**APPLICATION FOR PERMISSION
UNDER SECTION 16 OF
THE TOWN PLANNING ORDINANCE
(CAP.131)**

SECTION 16 APPLICATION TPO (CHAPTER 131)
PROPOSED FILLING AND EXCAVATION OF LAND FOR PERMITTED HOUSE
(NEW TERRITORIES EXEMPTED HOUSES)
IN "VILLAGE TYPE DEVELOPMENT" ZONE
AT LOTS 318 S.B SS.1 AND 318 S.B R.P. IN D.D. 122 PING SHAN YUEN LONG
(Town Planning Application No. A/YL-PS/656 – Submission of Further Information)

**SECTION 16 APPLICATION TPO (CHAPTER 131)
PROPOSED FILLING AND EXCAVATION OF LAND FOR PERMITTED HOUSE
(NEW TERRITORIES EXEMPTED HOUSES)
IN "VILLAGE TYPE DEVELOPMENT" ZONE
AT LOTS 318 S.B SS.1 AND 318 S.B R.P. IN D.D. 122 PING SHAN YUEN LONG
(Town Planning Application No. A/YL-PS/656 – Submission of Further Information 2)**

**SECTION 16 APPLICATION TPO (CHAPTER 131)
PROPOSED FILLING AND EXCAVATION OF LAND FOR PERMITTED HOUSE
(NEW TERRITORIES EXEMPTED HOUSES)
IN "VILLAGE TYPE DEVELOPMENT" ZONE
AT LOTS 318 S.B SS.1 AND 318 S.B R.P. IN D.D. 122 PING SHAN YUEN LONG
(Town Planning Application No. A/YL-PS/656 – Submission of Updated Further Information 2 and
Supersedure of the Original Further Information 2)**

Proposed Drainage Plan with Hydraulic
Calculation and Existing Site Photos

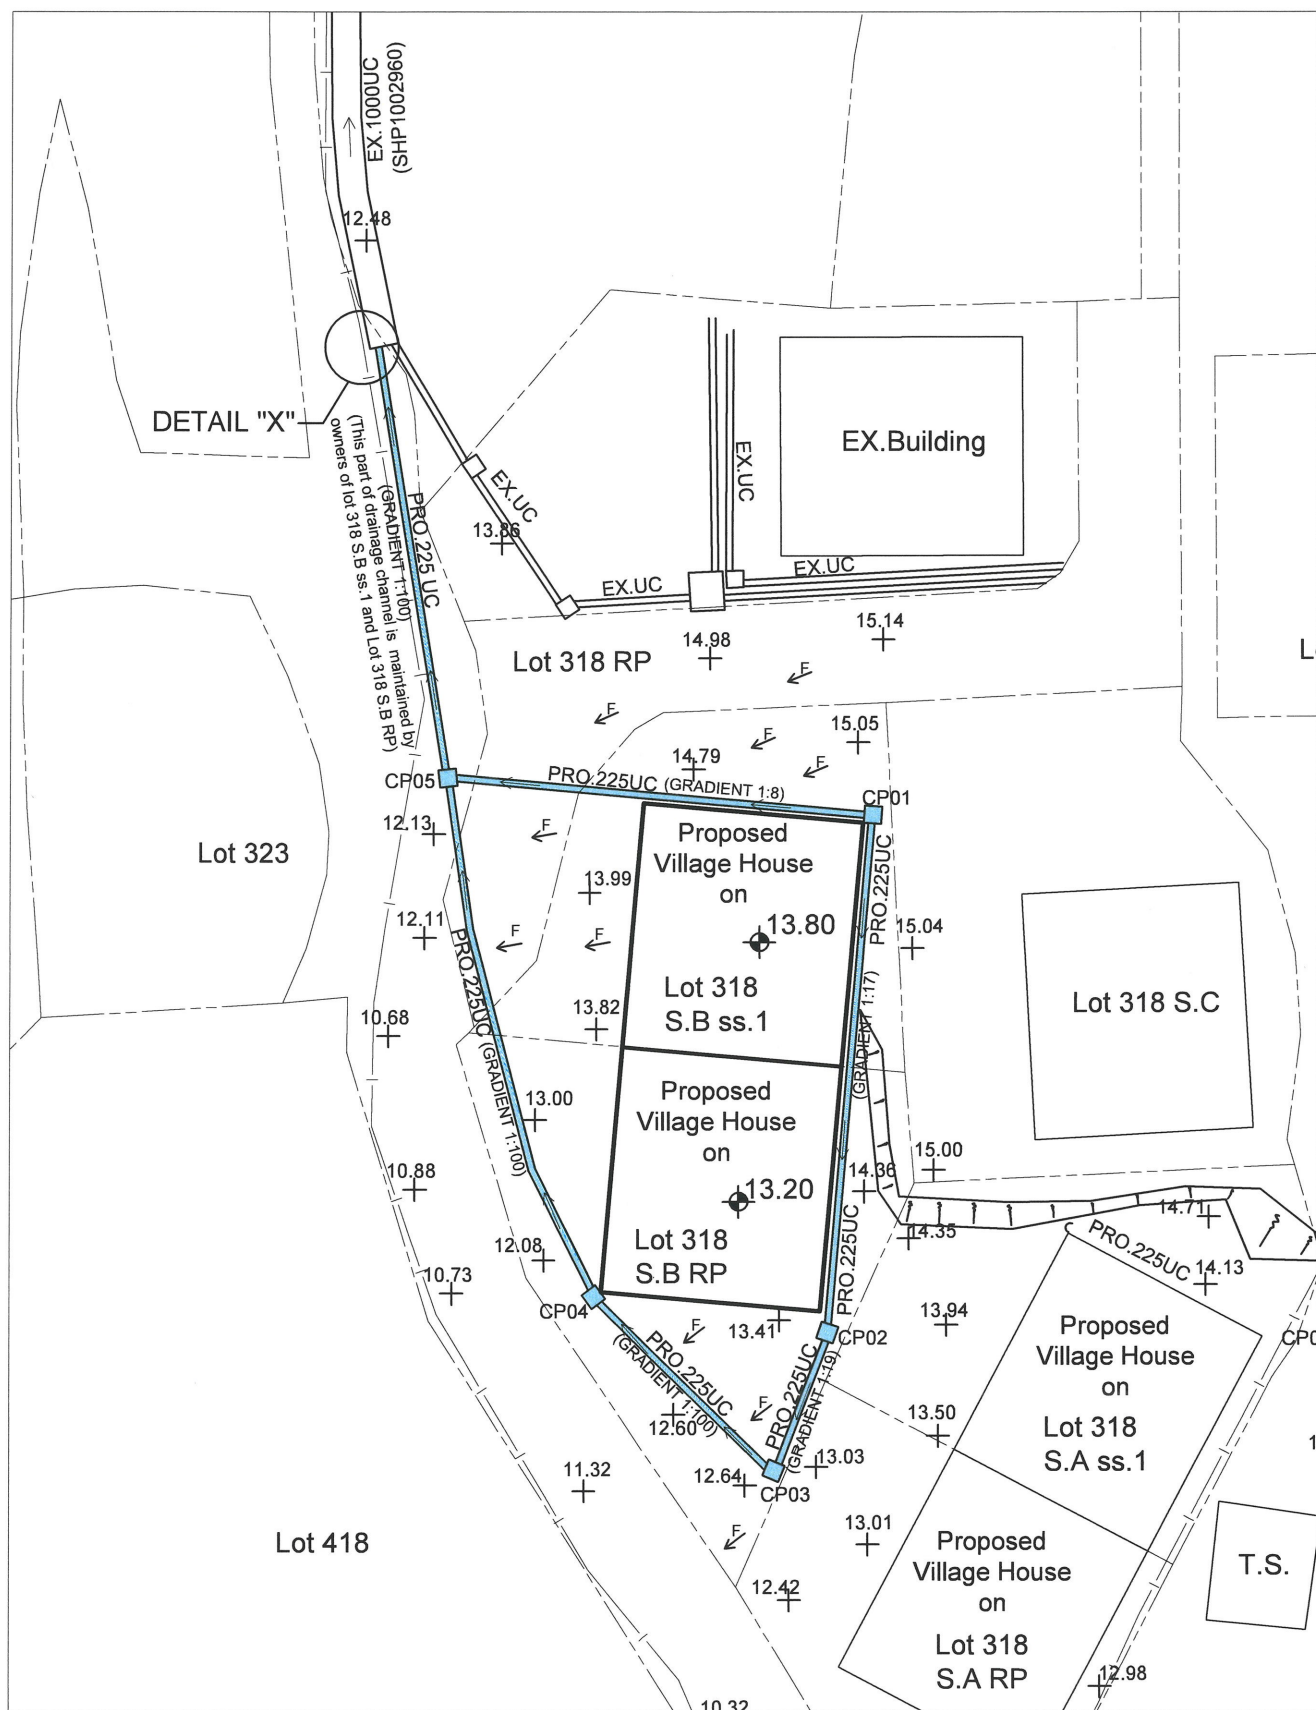
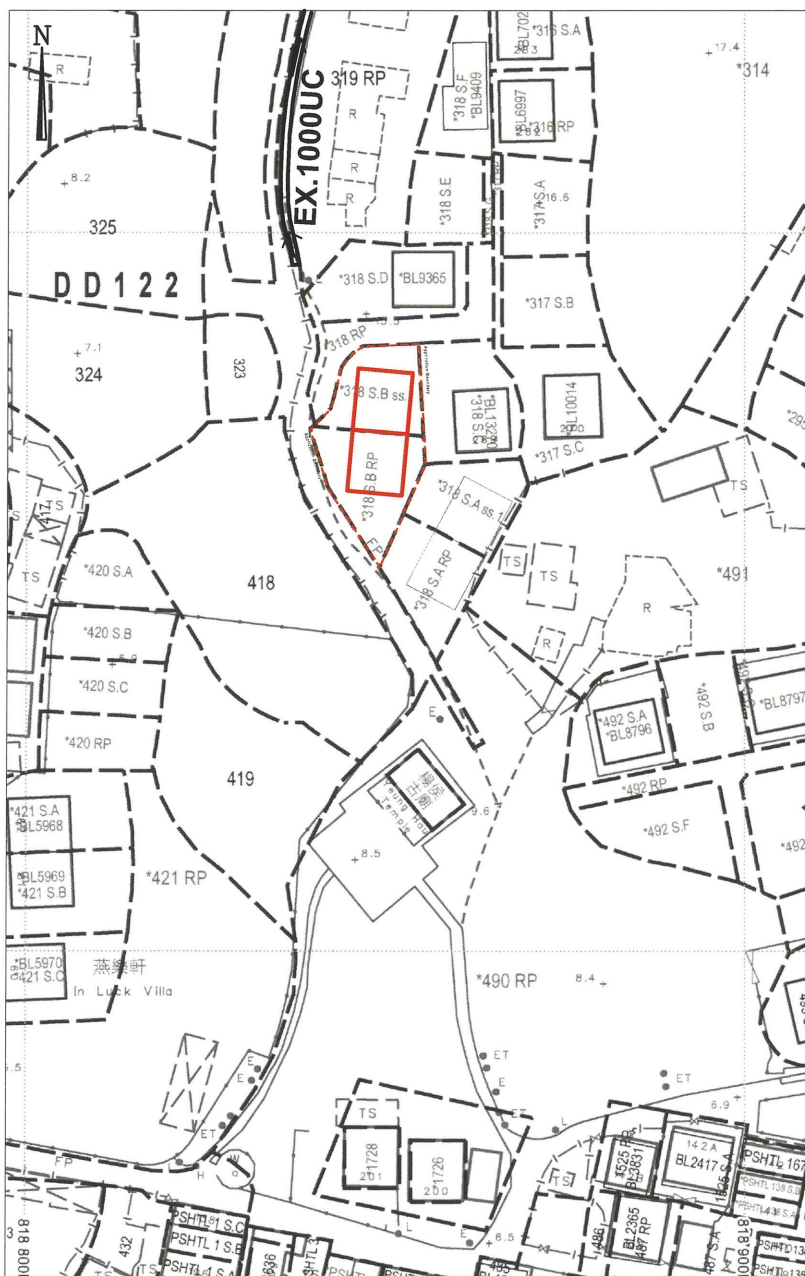
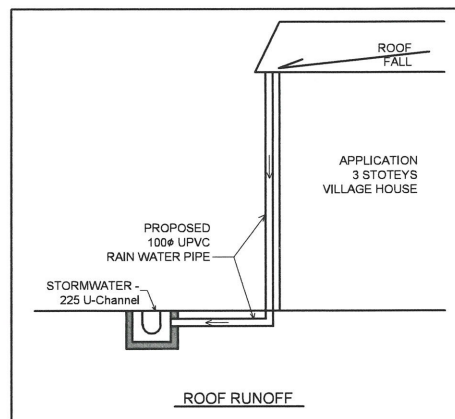
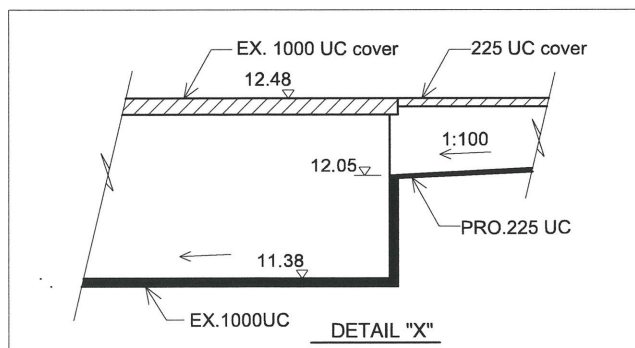
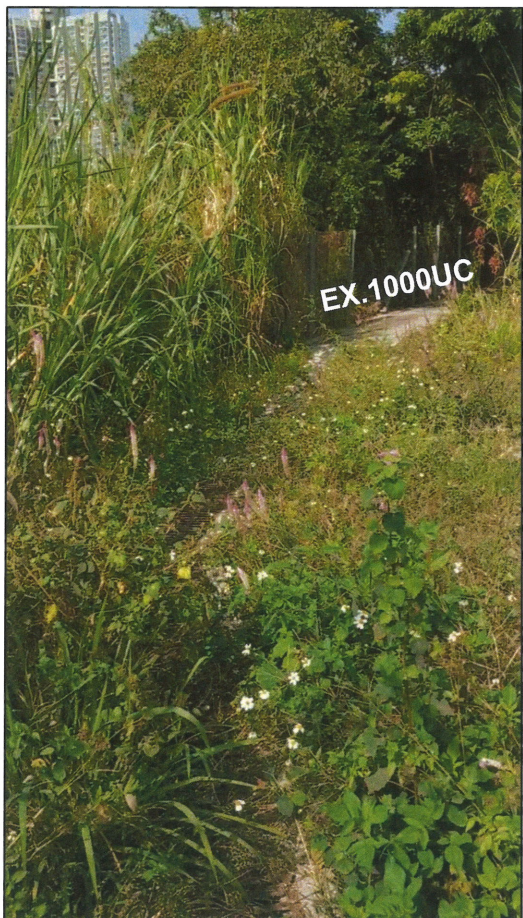
Departmental Comments	Response
<u>Email dated 14th April 2022 refers:</u> <u>DSD:</u>	
(i): Please demonstrate with hydraulic calculation that the proposed drainage facilities are adequate to collect, convey and discharge the surface runoff accrued on the application site and the overland flow intercepted from the adjacent lands. The applicant should also demonstrate the existing channel to be discharged to have sufficient capacity to cater for the additional flow generated by the application site.	The Attachment 1 provides the hydraulic calculation that the proposed drainage facilities are adequate to collect, convey and discharge to surface runoff accrued on the application site and the overland flow intercepted from the adjacent lands. The proposed drainage facilities also have sufficient capacity to cater for additional flow generated by the Site.
(ii): The ground to the north of the application site is generally higher. Since the overland flow from the adjacent lands shall be probably intercepted, external catchment shall be considered in the calculation.	Noted with thanks. External catchment (Area D) has been considered in the calculation.

(iii): Please indicate clearly the full alignment of the discharge path from the application site all the way down to the ultimate discharge point (e.g a well-established public drainage system).	Please see the drainage plan with full alignment of the discharge path in Attachment 1 for your information.
(iv): The existing channel, to which the applicant proposed to discharge the stormwater from the subject site was not maintained by this office. The applicant should identify the owner of the existing drainage facilities and obtain consent from the owner prior to commencement of the proposed works. In the case that it is a local village drains, DO/YL should be consulted.	DO/YL responded that they have no information about the concerned drainage facilities. They observed that the drainage facilities have adapted the CEDD's standard design and presumed they are managed by government bodies. The applicant would be happy to identify the owner of the existing drainage facilities at the construction stage and obtain consent from the owner prior the commencement of the

proposed works.
(v): Further to (iv) above, since there is no record of the said discharge path, please provide site photos to demonstrate its presence and existing condition.	Please see the existing site photos in Attachment 1 for your information.
(vi): The gradients of the proposed U-channels should be shown on the drainage plan.	Please see the drainage plan with gradients of the proposed U-channels in Attachment 1 for your information.
(vii): Cross sections showing the existing and proposed ground levels of the captioned site with respect to the adjacent areas should be given.	Cross sections have been provided in the Appendix A (Plans and Drawings) from the original planning submission. Please note that the Site level will not be changed after the proposed work.
(viii): Sand trap or provision alike should be provided before the collected runoff is discharged to the public drainage facilities.	Please see the drainage plan with 'trap' (sand trap) annotated in Attachment 1 for your information.

In order to further address the concerns by DSD, we would like to supersede the original version of FI2 submitted on 5th May 2022 by the new version of FI2 attached below. Please find attached response-to-comment (R to C) table and the updated proposed drainage plan with hydraulic calculation and existing site photos in **Attachment 1**.

STORMWATER
DRAINAGE WORK
DETAIL "X"

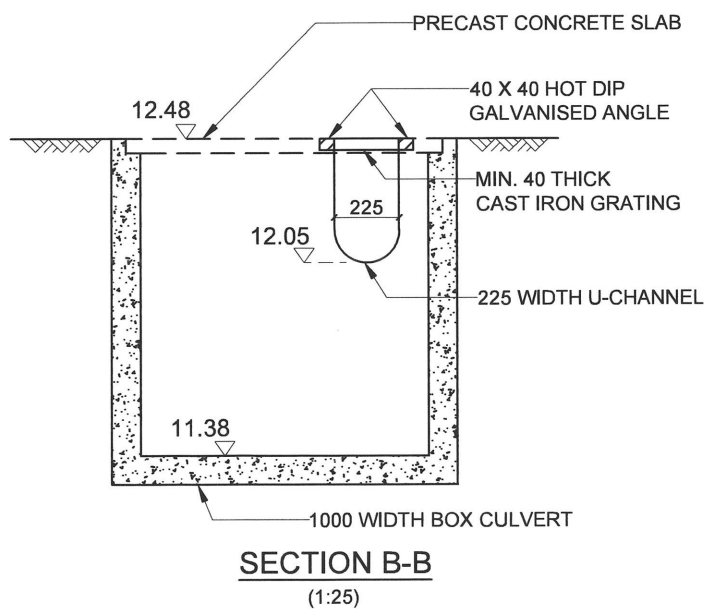
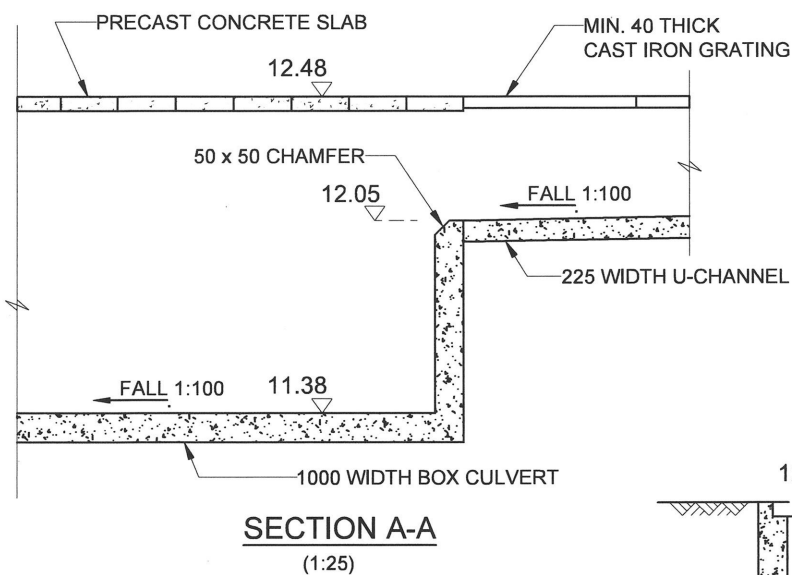
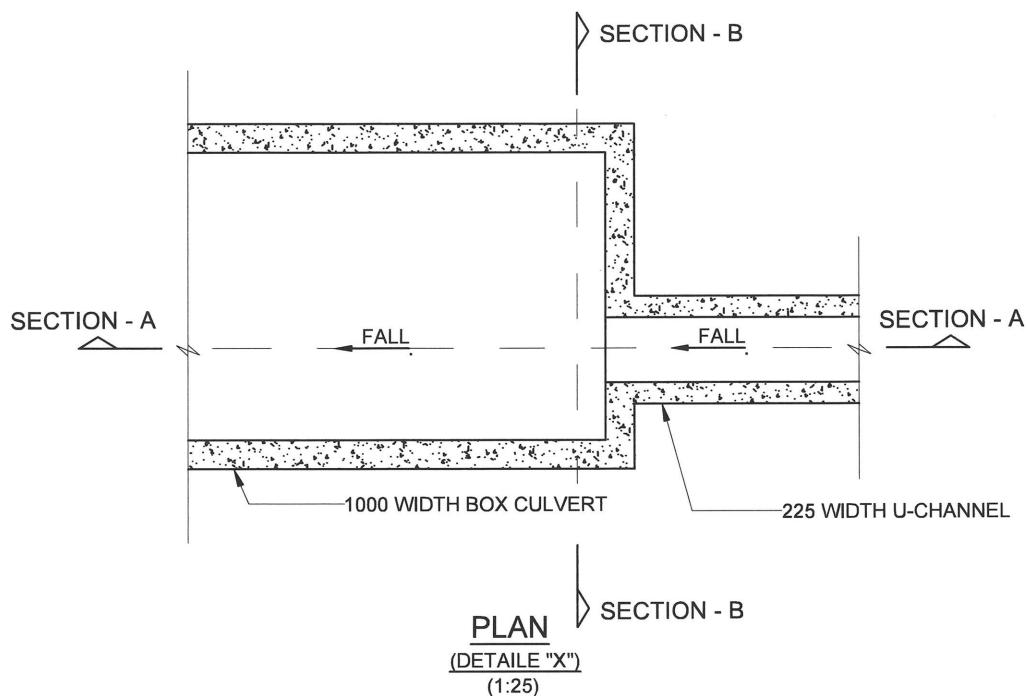
Departmental Comment	Response
Email dated 18th May 2022 refers: DSD:	
It is noted that the applicant is proposed to discharge the runoff to 1000mm channel which is DSD's facilities. The applicant is requested to provide connection details for further vetting.	Please see the attached Drawing No. 1.

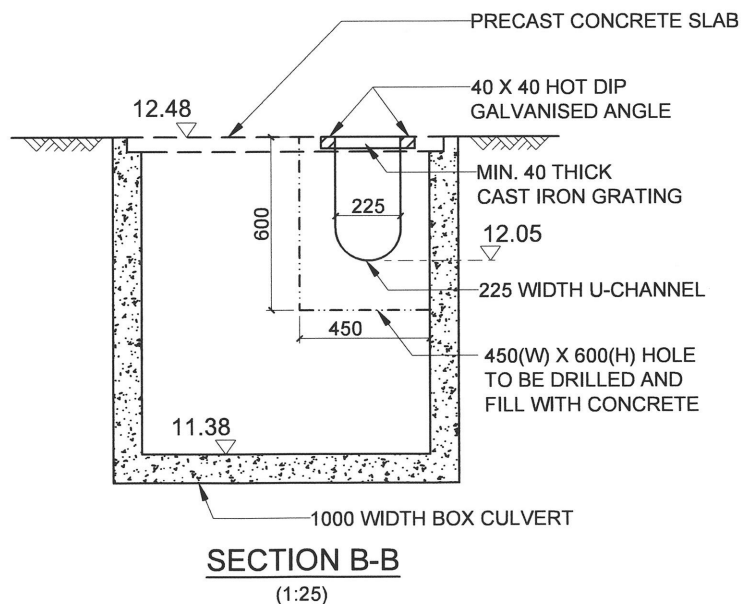
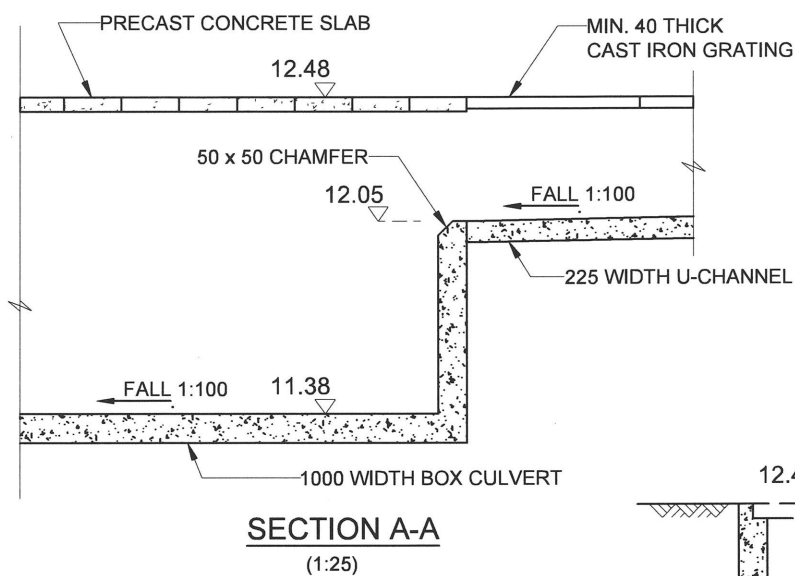
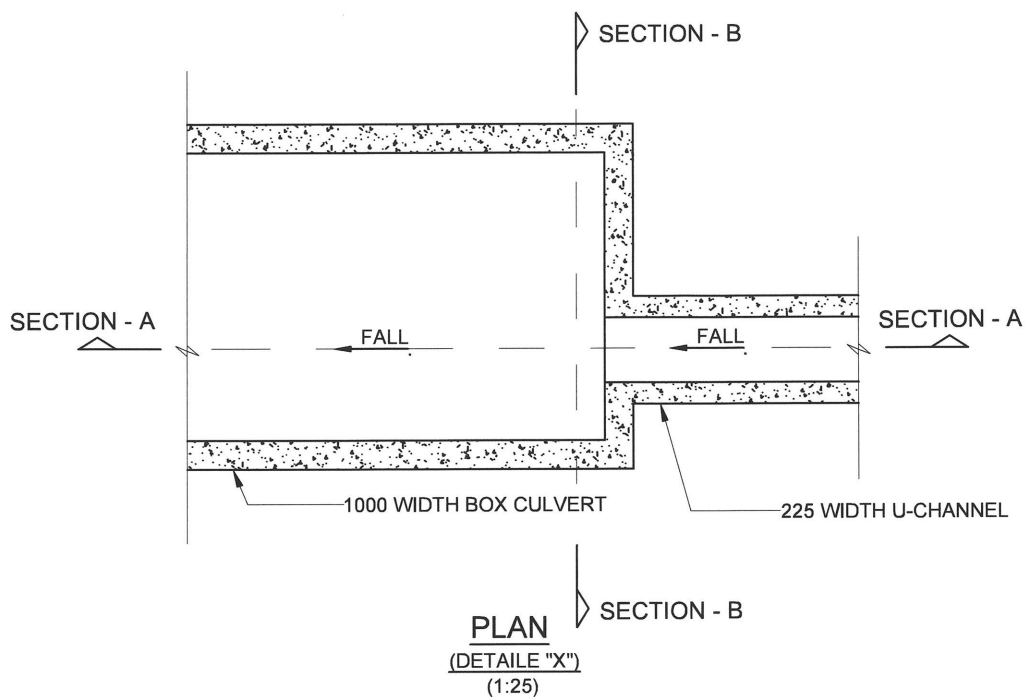
Departmental Comment	Response
Email dated 18th May 2022 refers: DSD:	
It is noted that the applicant is proposed to discharge the runoff to 1000mm channel which is DSD's facilities. The applicant is requested to provide connection details for further vetting.	Please see the attached Drawing No. 1.

Please find attached response-to-comment (R to C) table and the updated drainage connection details in **Drawing No. 1.**

STORMWATER
DRAINAGE WORK
DETAIL "X"

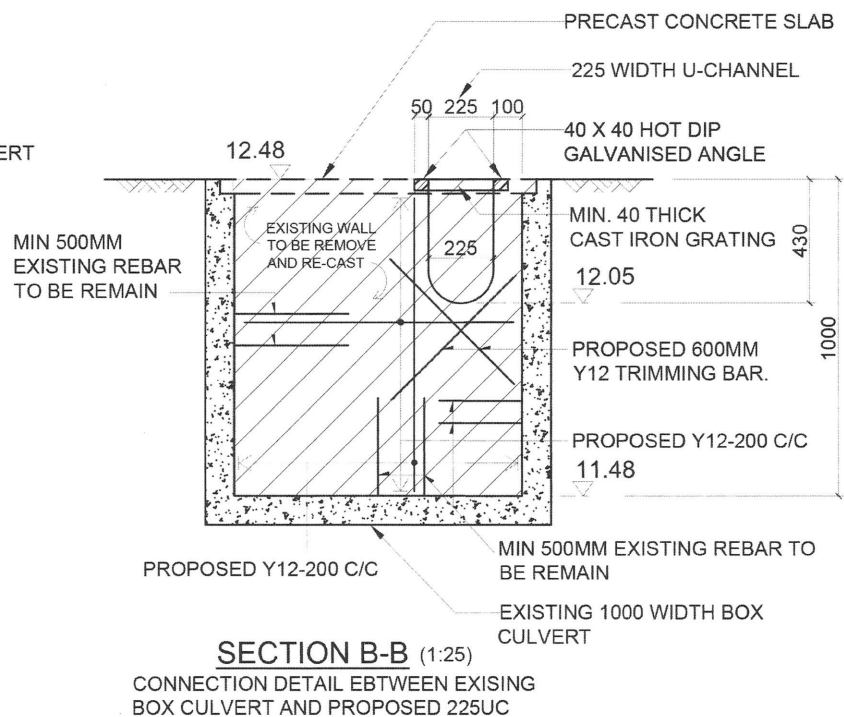
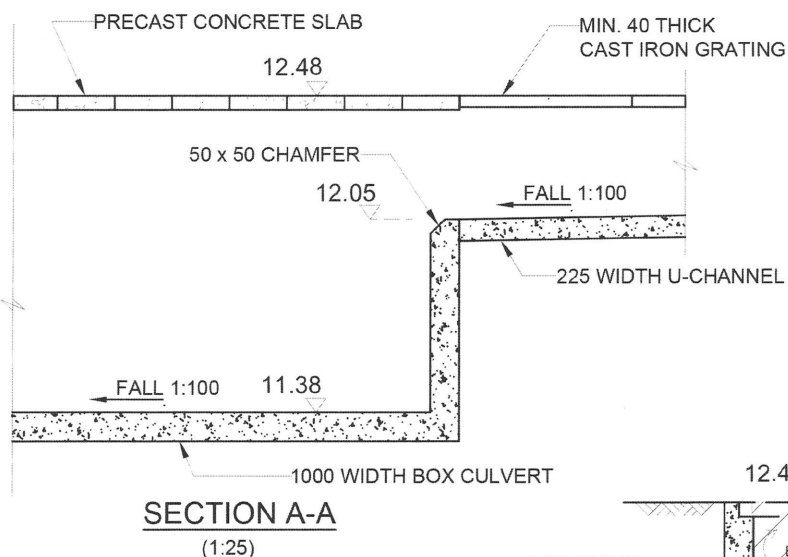
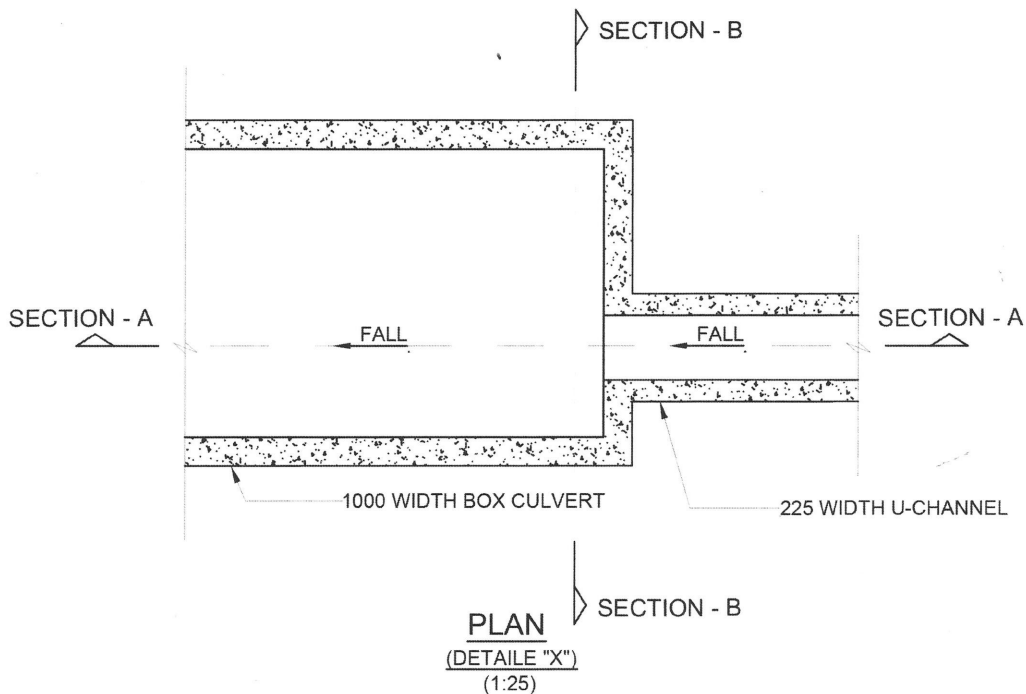
Departmental Comment	Response
Email dated 18th May 2022 refers: DSD:	
It is noted that the applicant is proposed to discharge the runoff to 1000mm channel which is DSD's facilities. The applicant is requested to provide connection details for further vetting.	Please see the attached Drawing No. 1.

Please find attached response-to-comment (R to C) table and the updated drainage connection details in **Drawing No. 1.**
